Coastal Access Modification Report GAL-MR3

Proposed changes to the submitted King Charles III England Coast Path proposals for Gretna to Allonby, Cumbria

Location affected: Longcroft/Whitrigg, Kirkbride

Natural England's Modification Report to the Secretary of State

Coastal Access - Gretna to Allonby - Natural England's Proposed Modification to Proposed Route
Map GAL-MR3c Longcroft/Whitrigg, Kirkbride - Restrictions and Exclusions

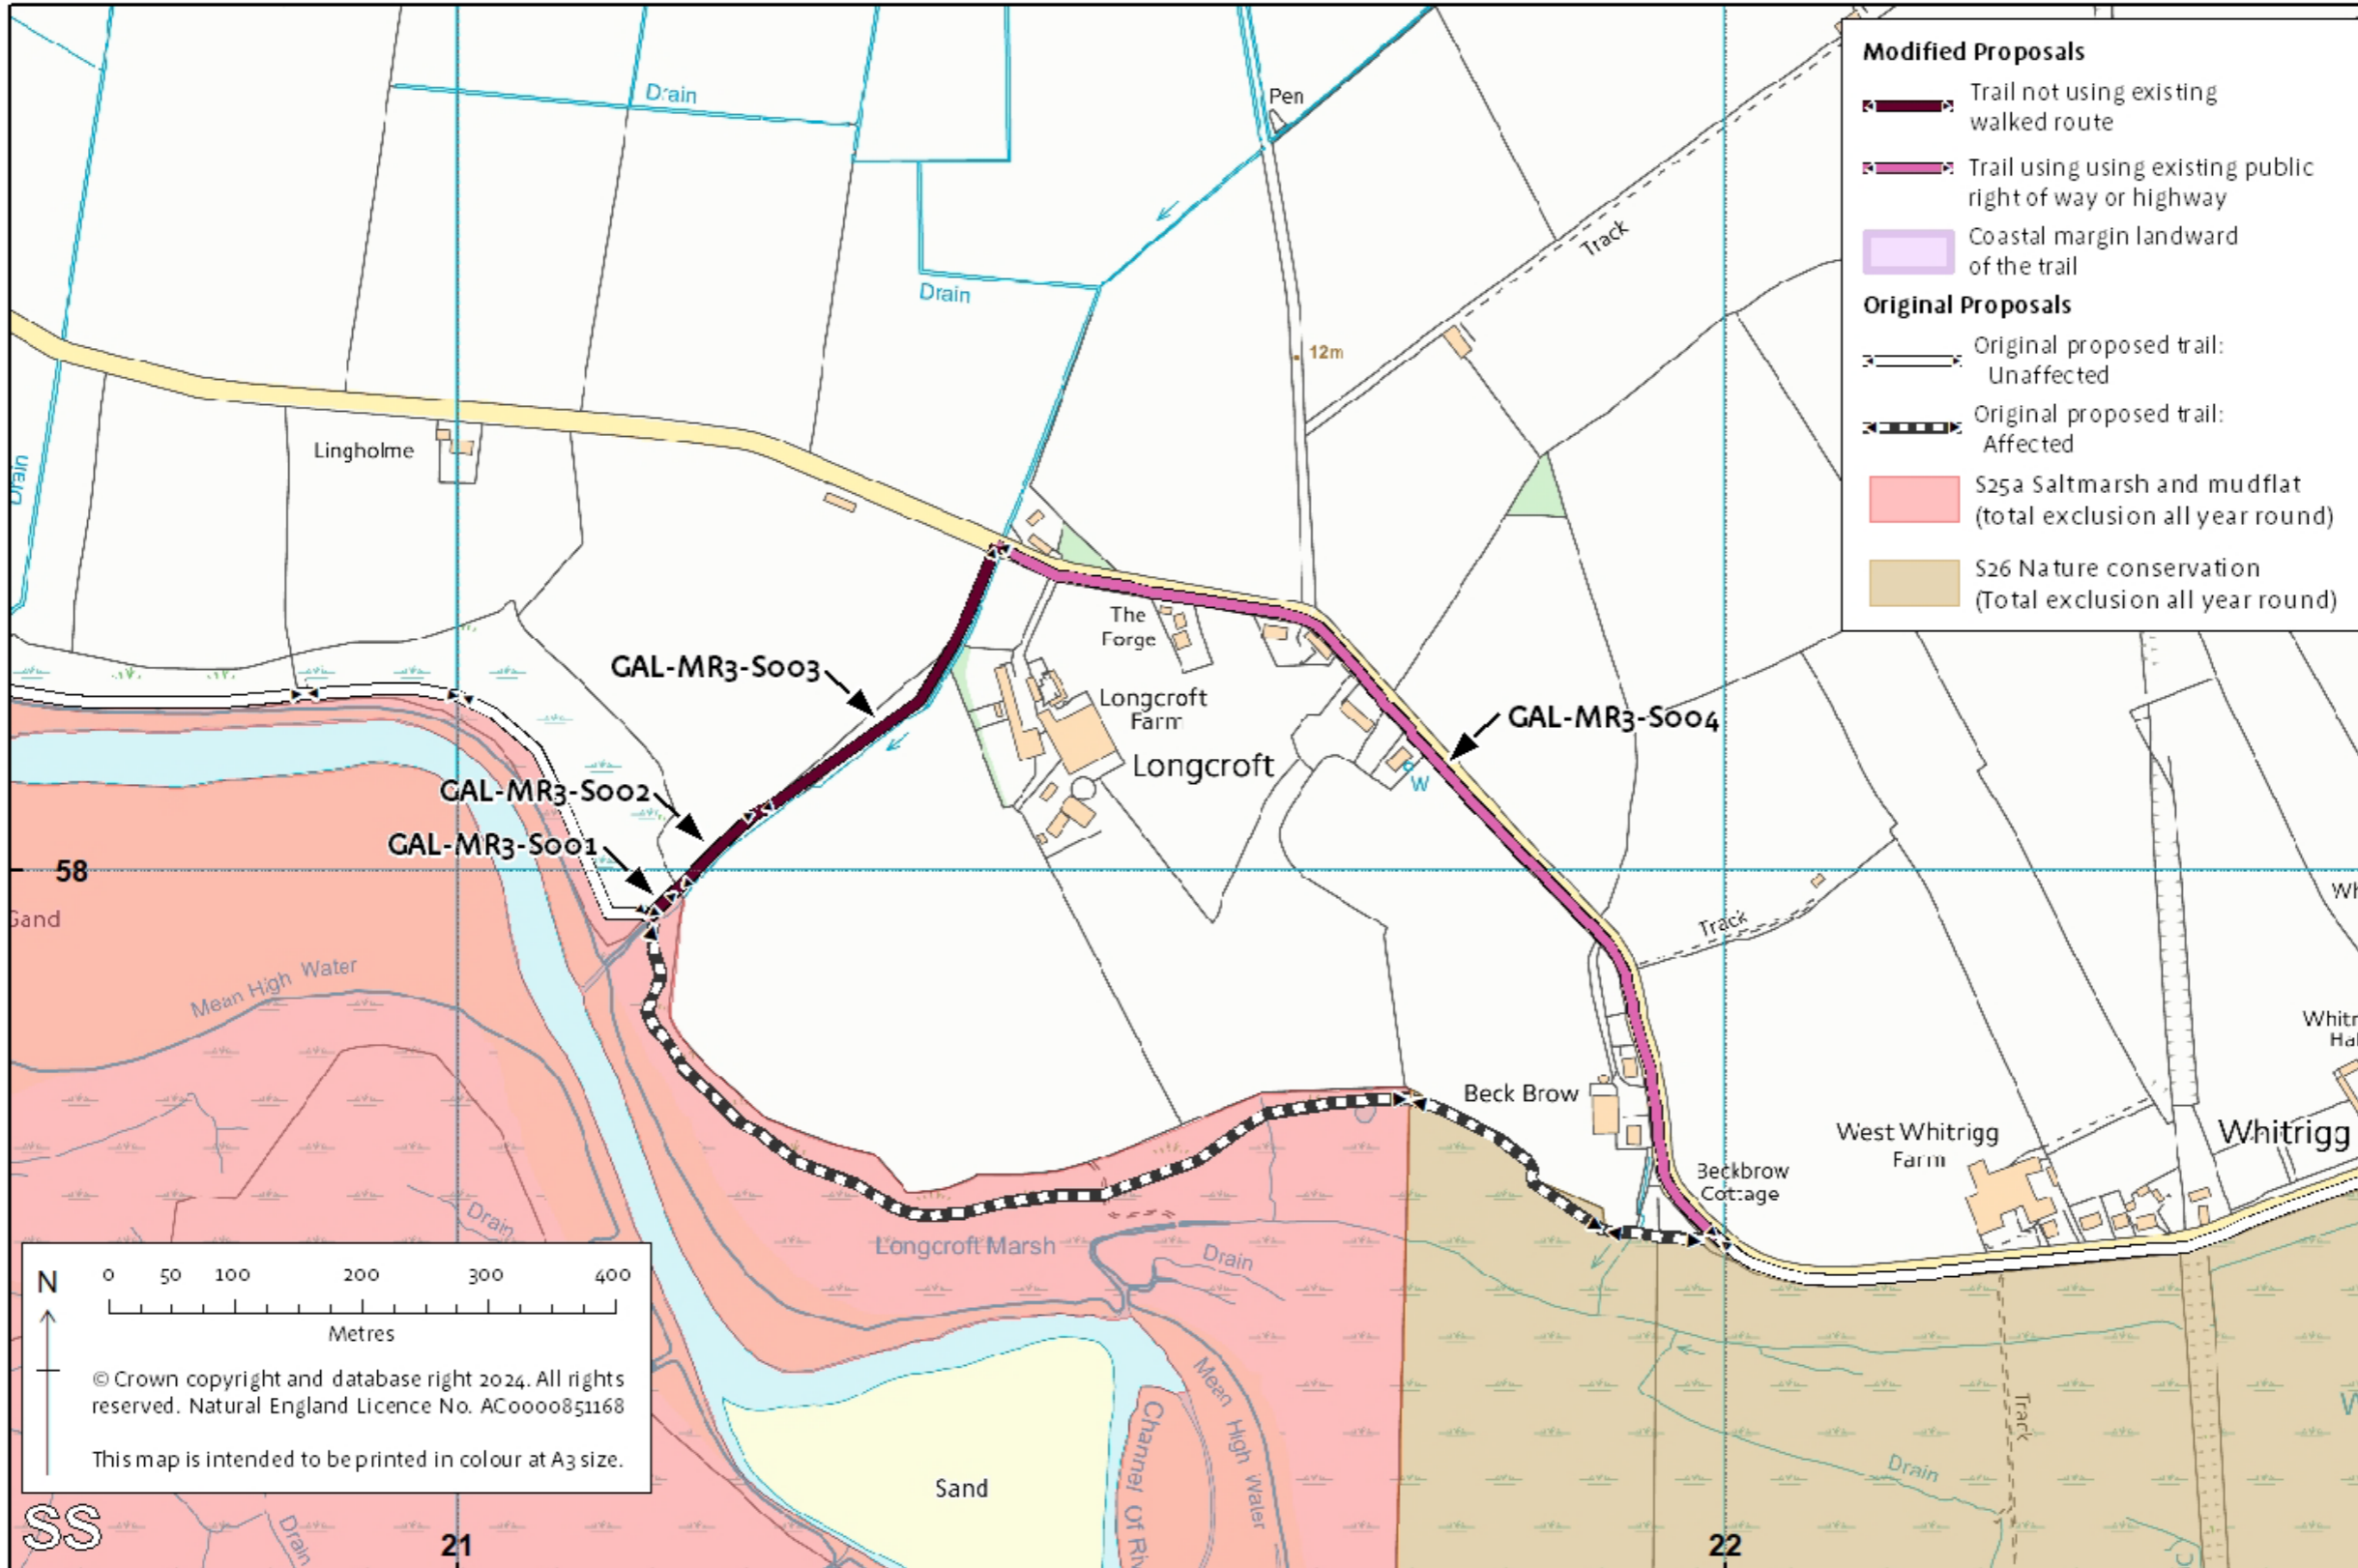
A.2.10 Access to the saltmarsh and mudflat in the coastal margin seaward of route sections GAL-MR3-S001 to GAL-MR3-S004 (Longcroft Marsh) is to be excluded all-year round by direction under section 25A of the Countryside and Rights of Way Act (2000) as this area is unsuitable for public access. These exclusions do not affect the route itself and will have no legal effect on land where coastal access rights do not apply. See Direction Map GAL-MR3c.

A.2.11 Access to the saltmarsh and mudflat in the coastal margin seaward of the eastern part of route section GAL-MR3-S004 is to be excluded all-year round by direction under section 26(3)(a) of the Countryside and Rights of Way Act (2000), in order to prevent disturbance to birds. These exclusions do not affect the route itself and will have no legal effect on land where coastal access rights do not apply. See Direction Map GAL-MR3c.
